MANCHESTER CITY COUNCIL

**APPENDIX TO AGENDA
(LATE REPRESENTATIONS)**

Planning and Highways Committee 14 March 2019

Scale 1:50 @ A1 Date 13/03/2019 Drawing No 475.L15.04.A

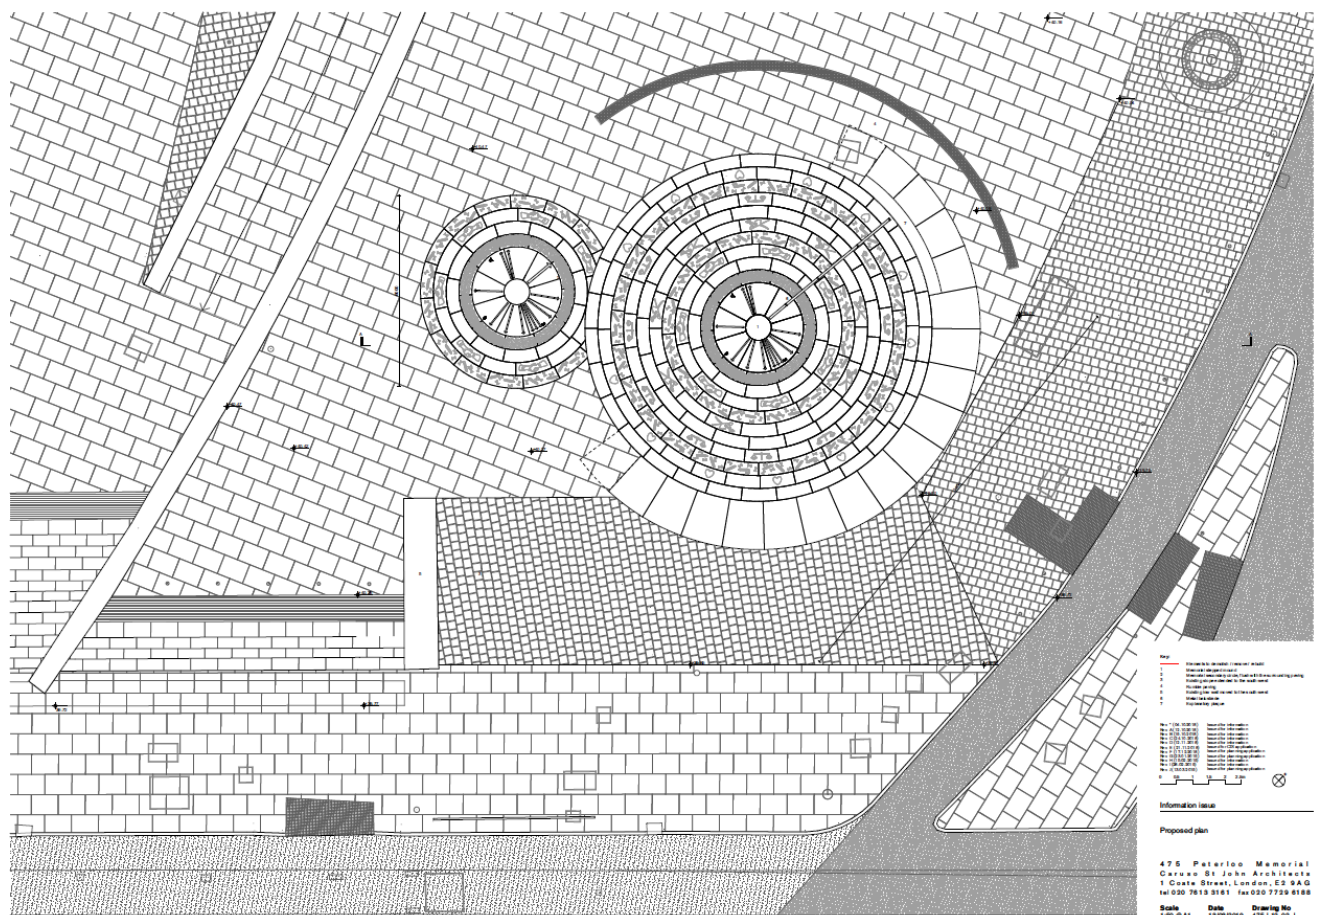
10 objections have been received which support the principle but object on the basis that the monument is inaccessible to wheelchair users. The proposal should truly promote the aspiration for which so many people gave their lives...Equality.

The smaller ground level circle is provided because some (disabled) people will not be able to access the monument. This is like saying to disabled people...'Most people go in here...but you can have your own separate access'. This might be acceptable when adapting an existing structure but this would be a completely new structure where access should be equal.

The flat wheelchair accessible version of the memorial feels a little insulting. There are many people who will be unable to walk up the steps and 'stand' on the top of the memorial.

3. The applicant

The adjustment that is required to improve access to the lower level could require the use of land outside of the site edged red. This would be a strip of no wider than 1100mm around about half of the base of the monument. This is shown on the attached plan. This is a modest amendment that would deliver an important outcome and would not materially alter the proposal as originally submitted.

Before the above ground works hereby permitted commence, full and final details of the materials to be used to widen the first step of the memorial to 1.5m, shall have been submitted to and approved by the City Council as local planning authority. These details shall be implemented before the memorial hereby permitted is brought into use and shall be retained and operational for so long as the memorial is in use.

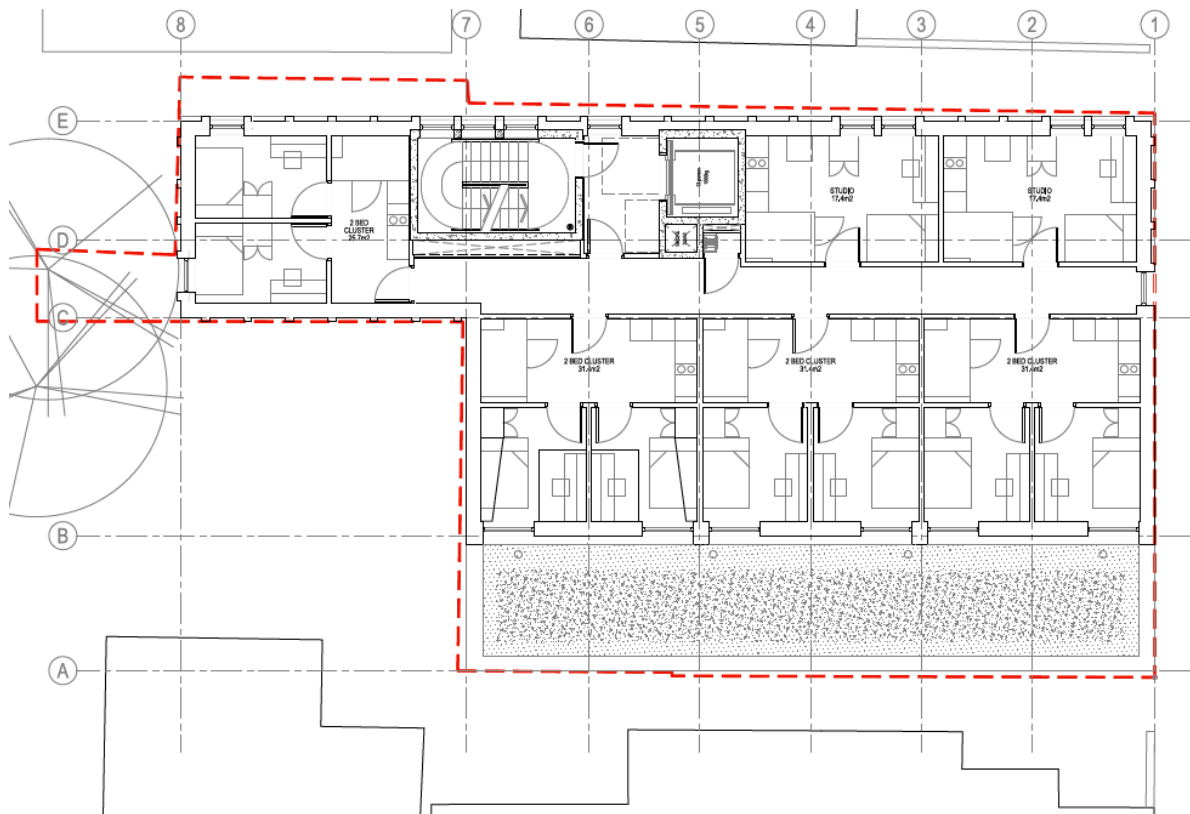
With reference to concerns in relation to loss of privacy, the first floor plan included below shows the relationship of the building to the site boundaries. It shows that there are a limited number of windows to the rear elevation in an offset position, 7.5m from the three storey flats at 2 – 12 Elmdale Walk, preventing overlooking.
